Subject: Turbulators (Zig-Zag-tapes) for winglets, horizontal and vertical tail planes

Serial number applicability: All ASW 28-18, 28-18E

Fig. 1 - Horizontal Tail

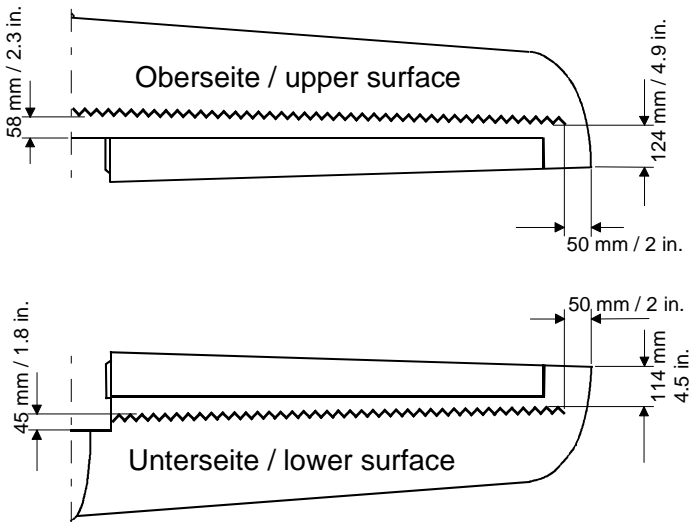
Action: According to the positions given in drawings of Fig. 1 through 3 Zig-Zag-Tapes of the specified kind are attached to the inboard surface of the winglets, on upper and lower surface of the horizontal tail planes and on both sides of the vertical tail.
